January 31, 2013

MEMORANDUM

SUBJECT: Permit Renewal Staff Analysis: City of Dubois Wastewater Treatment and Reuse Facility; M-166-03.

Figure 5.1 Hydraulic loading rates

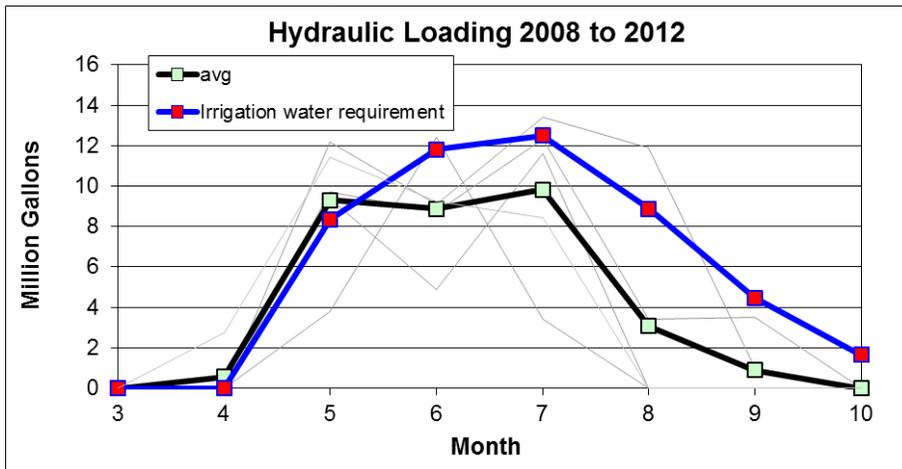
Effluent characteristics are shown in Table 5.1; hydraulic loading volumes are shown in Figure 5.1. Note that the irrigated acreage is actively monitored and managed for soil moisture by the farmer managing the field; therefore, actual hydraulic application may not match theoretical irrigation water requirements.

Averaged hydraulic loading at the Dubois facility (see Figure 5.1, above) follows the irrigation water requirement (IWR, University of Idaho, Kimberly R & E Center) trend. The crops are actively managed for irrigation needs, including soil moisture content, so the textbook IWR may not be the best representation of actual irrigation needs.

Historically insufficient water volumes result in lower irrigation rates in the later summer, and only two alfalfa crops in 2012.

Table 5.2 Constituent Loading and Removal Totals

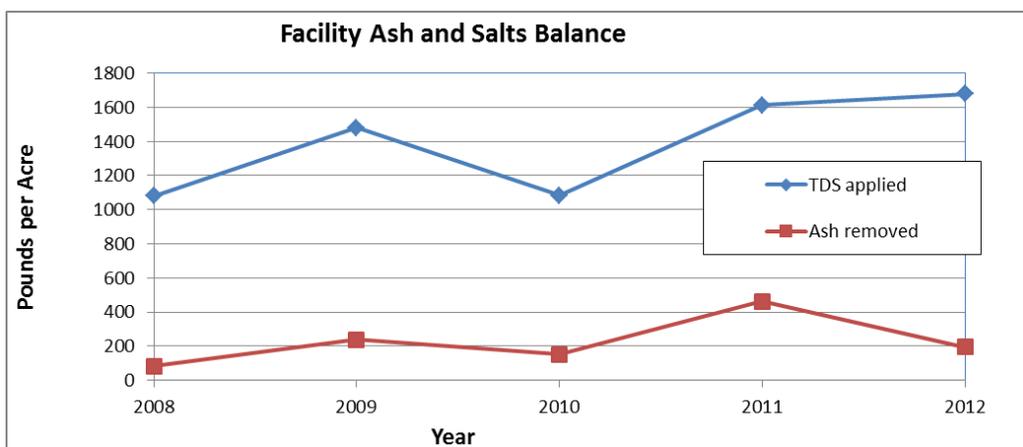
The facility balance for applied and removed constituents is given in Table 5.2 below. Recommended and actual loading rates are given in Table 5.3; note that nitrogen loading rates are well below 150% of crop uptake. The increasing TDS trend is most likely be due to algal growth in lagoon 3 and increasing irrigation water volumes over the years.

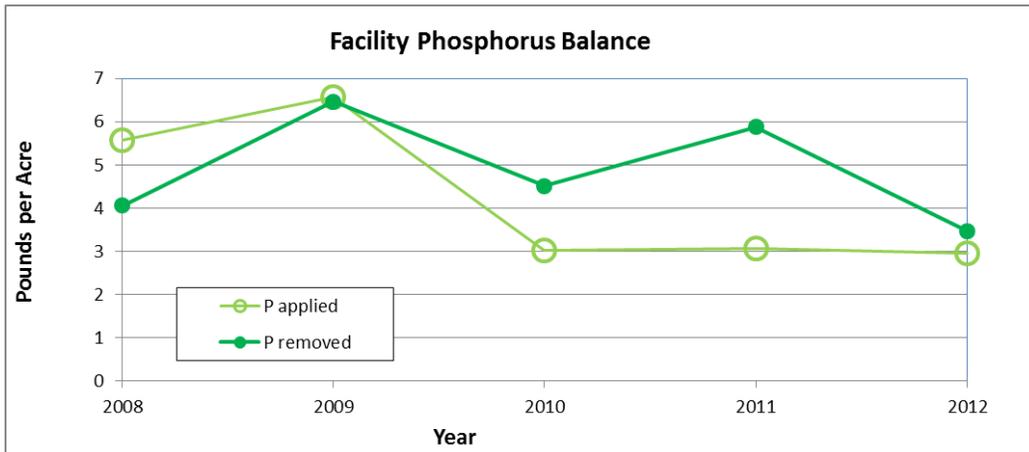
Nitrogen, phosphorus, and ash loading and removal rates are shown below. COD monitoring was removed from the previous permit, and not included in this permit, due to historic loadings well below recommended maximums.

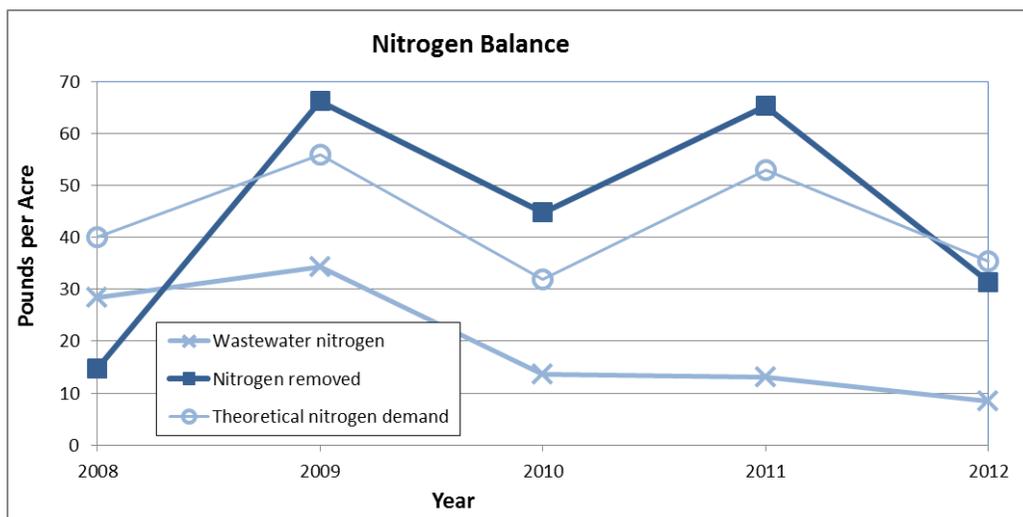
Nitrogen supplied and nitrogen requirements are listed below for comparison. The facility is in compliance with nitrogen loading requirements.
